ſ	PERMIT IS	SUED		
City of Portland, N	Maine - Building or Use	Permit Application	n Pe	rmit No: Issue I	ate:	CBL:	
389 Congress Street,	04101 Tel: (207) 874-8703	3, Fax: (207) 874-871	6 🔲	0 -0804 2 3	2001	016 C0	01001
Location of Construction:	Owner Name:		Owner	r Address:		Phone:	
74 Wilson St	Bonetti Maria	nna	Po B	Sox 483	A LTC	207-871-	4308
Business Name:	Contractor Nam	e:	Contra	actor Address:	LLA	Phone	
n/a	P.J. Consrtuct	ion	Gre	y		2078318	730
Lessee/Buyer's Name	Phone:		Permi	t Type:			Zone:
n/a	n/a		Alte	erations - Dwellings			K-L
Past Use:	Proposed Use:	. Addition to the second secon	Permi	it Fee: Cost of V	Work:	CEO District:	7
Two Family	•	Two Family / Renovate second		\$126.00 \$17,000.00		0 1	
		nt; new kitchen,	FIRE	DEPT: Approve		PECTION:	
	5	room, new stairs to expand third floor		Denied	Use	ERMITIS UE	Type: 5
N 20 19/2				W			ENTS
ok per 1955	vectory to rema	in 2 mut	_		Yest	arbana di Pangan	99

Proposed Project Description				7	\rightarrow	\bigcirc \bigcirc	Hill
Renovate Second floor	Apartment.		Signat			tomes	LAK.
			PEDE	STRIAN ACTIVITIES I)ISTRIC	T (P.A.D.)	- H
			Action	n: Approved	Approved	d w/Conditions	Denied
			Signat	ture:		Date:	
Permit Taken By:	Date A

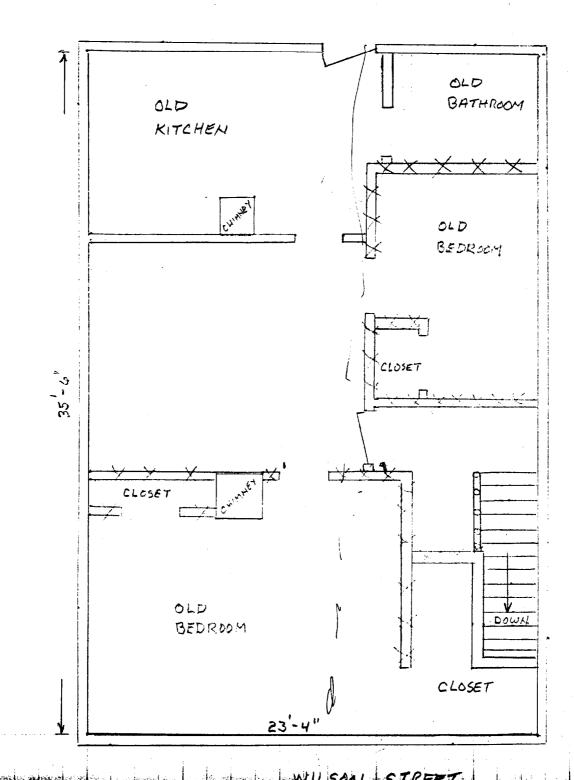
NOTE: RAIL POSTS 4!" H+ 42"

RAILING PRESENTLY 3612" HT OFF DECK A SECOND TOP

2"X4" RAIL WILL BE ADDED TO BRING HEIGHT

TO CODE, OF 42" MINIMUM.

PROJECT 74 WILSON ST - NEW 2 NO FLOOR LAYOUT

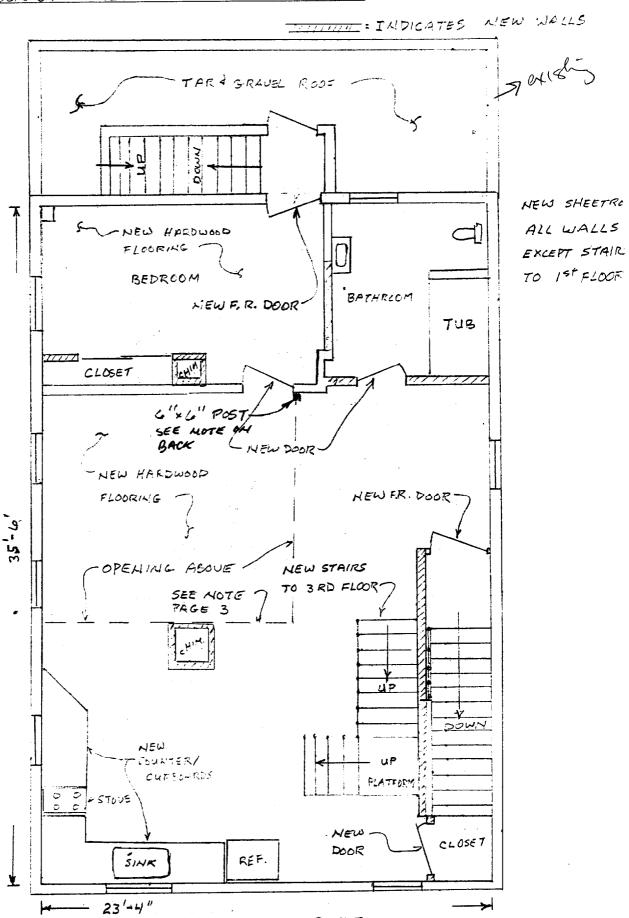
Sheet 2 was revised to show a post at southerly side of opening the northerly side of opening the 200's ran between carriage wells
